Office Action Summary

10/538,085

- 1) ☒ Responsive to communication(s) filed on 25 May 2006.
- 2a) ☒ This action is **FINAL**. 2b) ☐ This action is non-final.
- 3) ☐ Since this application is in condition for allowance except for formal matters, prosecution as to the merits is closed in accordance with the practice under *Ex parte Quayle*, 1935 C.D. 11, 453 O.G. 213.

FIG. 17

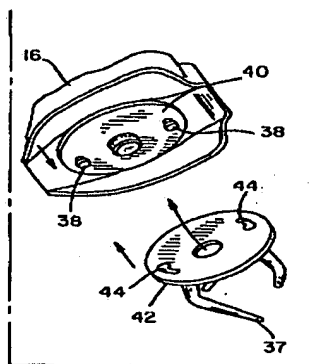
Marshall et al. shows that a cultivator tool comprising a circular flange with inwardly angled tines is an equivalent structure known in the art (fig. 17). Therefore, because these two cultivating means were art-recognized equivalents at the time the invention was made, one of ordinary skill in the art would have found it obvious to substitute a cultivating tool similar to that of Marshall et al., for the cultivating tool of Straayer.
